CITY OF BOULDER
PLANNING BOARD MEETING AGENDA
DATE: August 4, 2016
TIME: 6 p.m.
PLACE: 1777 Broadway, Council Chambers

5. **PUBLIC HEARING ITEMS**
   A. AGENDA TITLE: Public hearing to consider Site Review application, LUR2015-00012, to develop the Armory site (The Armory Community), an 8.55-acre site located at 4750 Broadway (the southeast corner of Broadway and Lee Hill Dr.), with a mixed-use project with up to 200 dwelling units and 8,400 square feet of storefront retail along Broadway and two new street connections (13th Street and Zamia Avenue). The proposal includes a 23 percent parking reduction request to permit 261 parking spaces where 341 are required, but otherwise contains no other modifications to the Land Use Code.

Applicant: Bruce D. Dierking
   Property Owner: The State of Colorado

C1.0

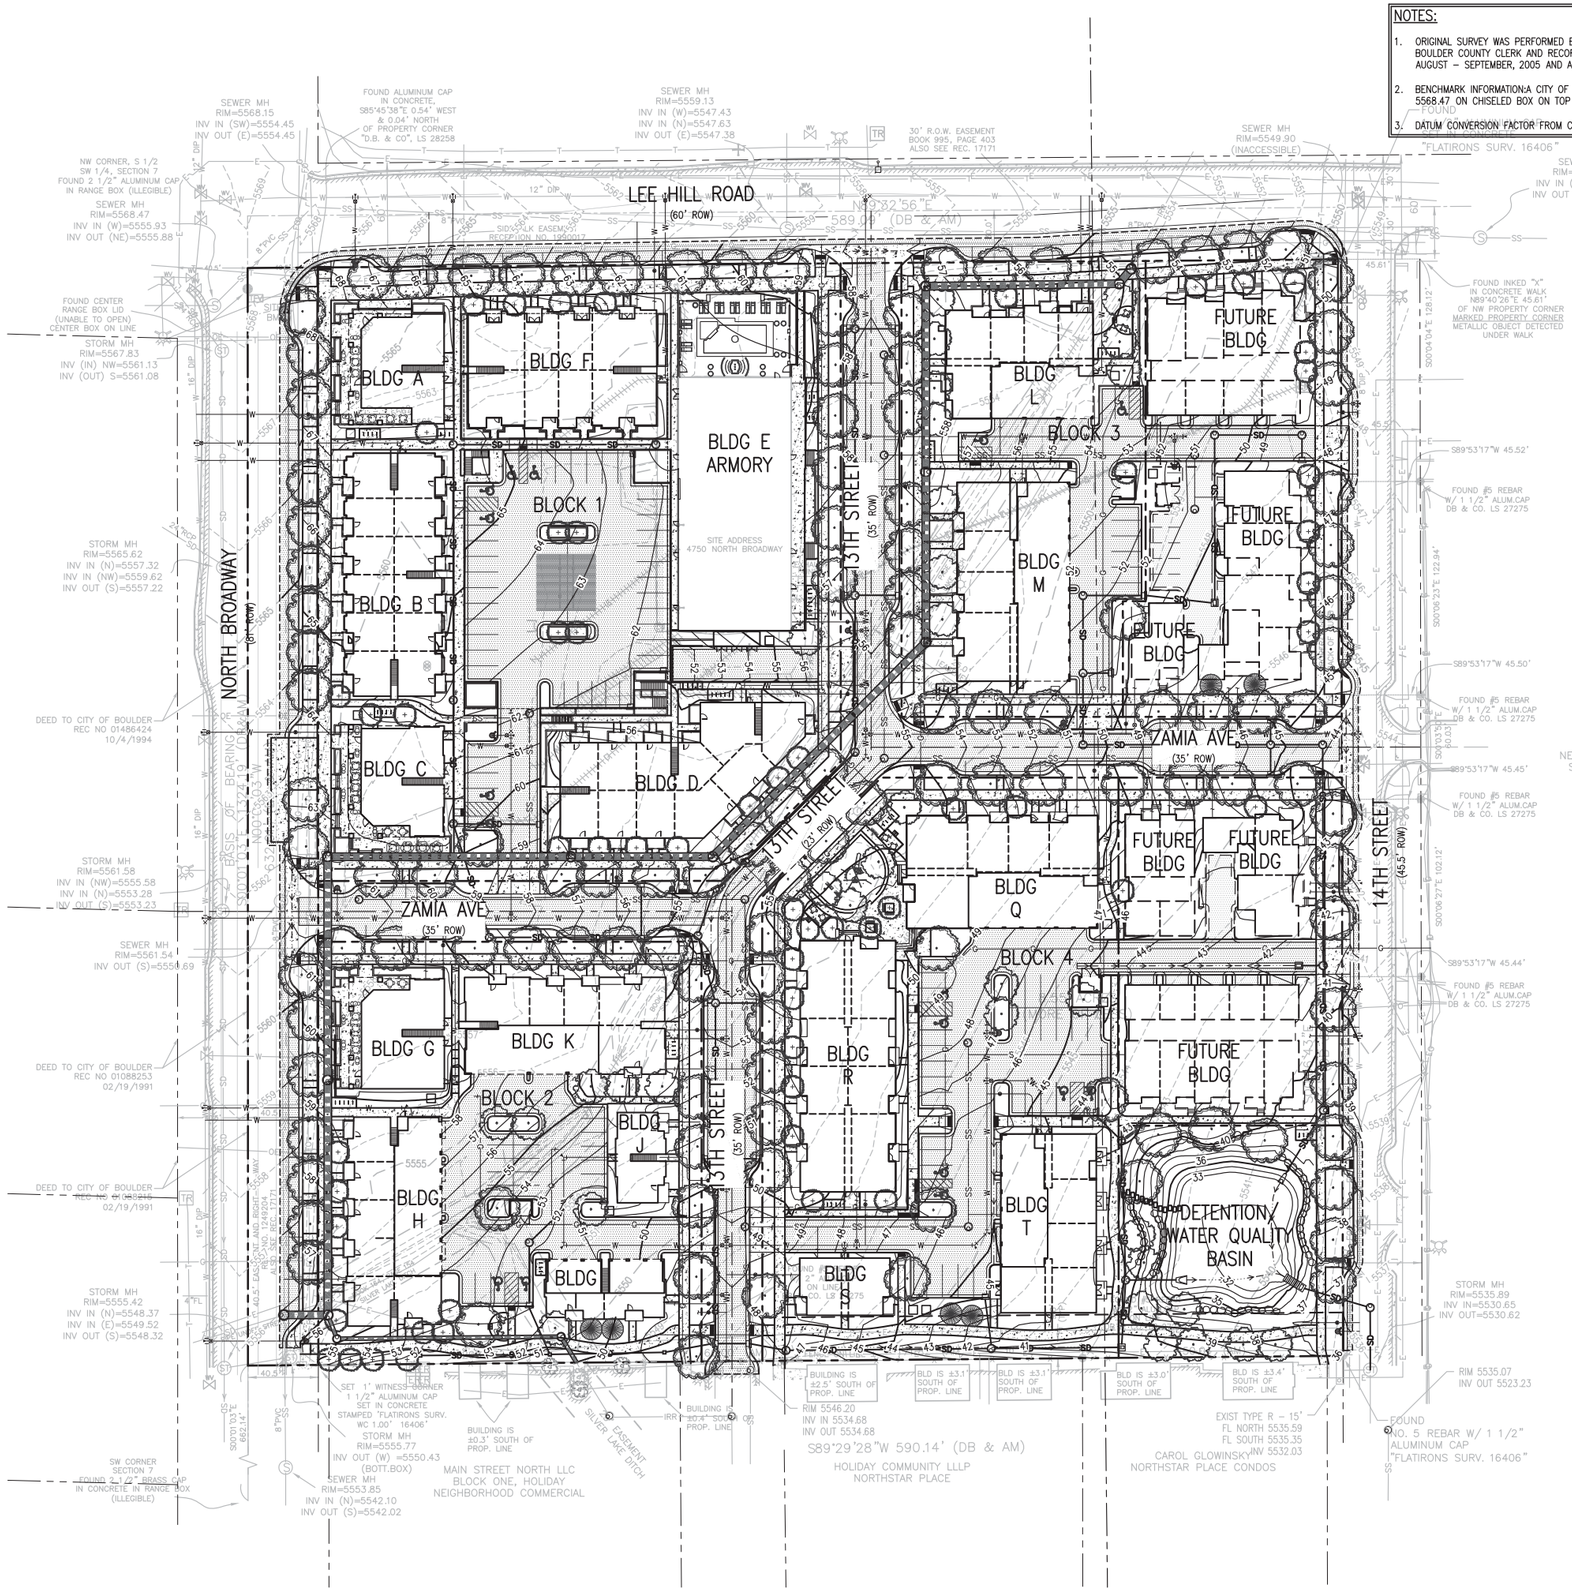
3. Sheet C1.1 shows two storm drainage inlets in the upper parking area of Block 1 with the note "Inlet in Parking Structure (RE: Plumb)". Since there are no plumbing plans it is unclear how and where the inlets will be connected to the storm drainage system. Revised accordingly.

C3.6

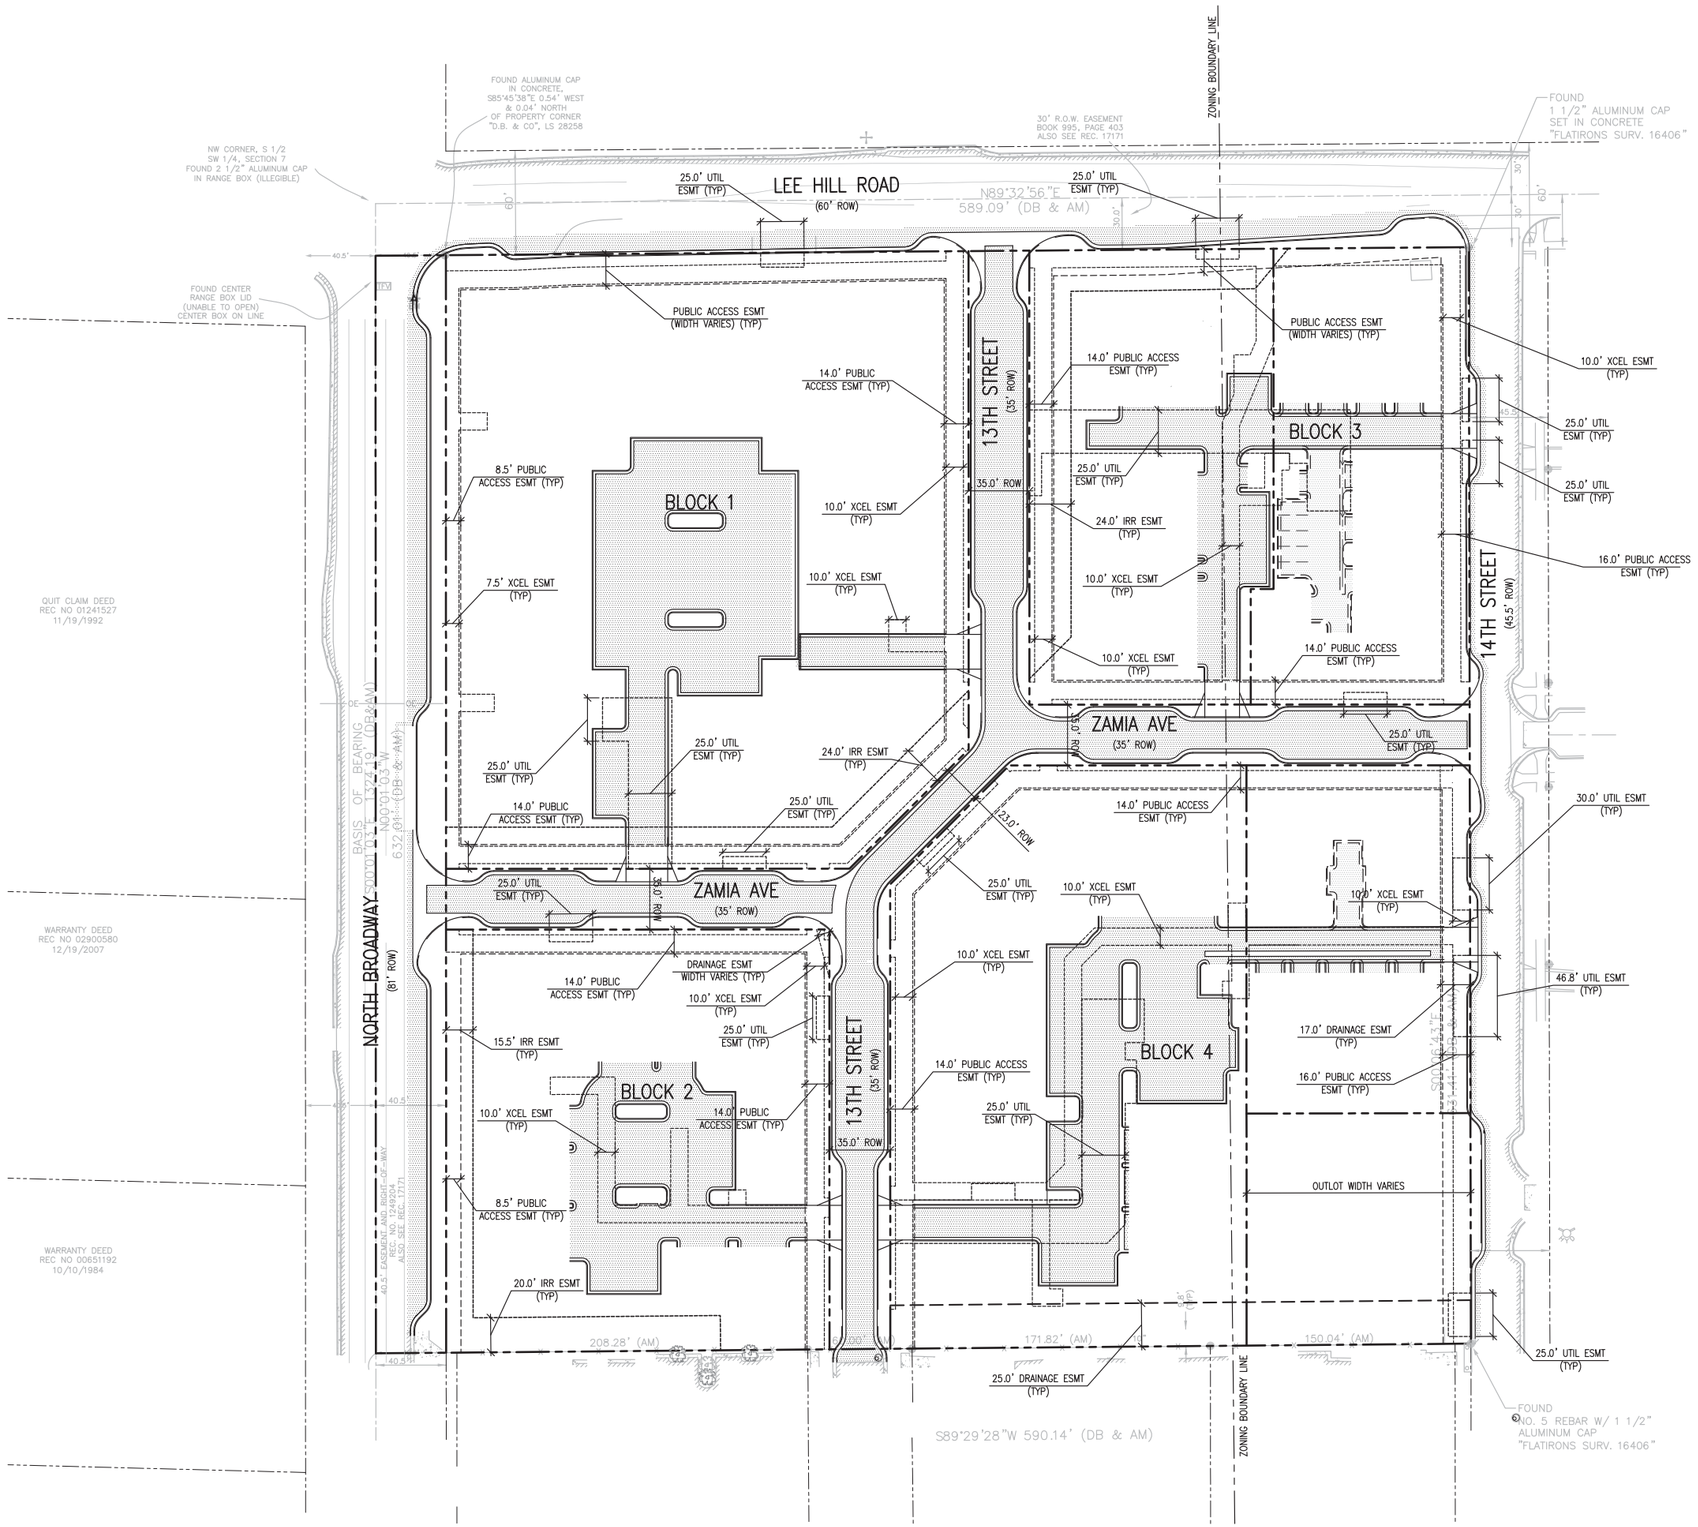
6. A minimum of 10 feet of additional utility easement is required beyond the fire hydrant assemblies in accordance with Section 5.10(A)(2) of the *DCS.* Please revise the Preliminary Lot & Easement Plan, Sheet C3.6 accordingly.
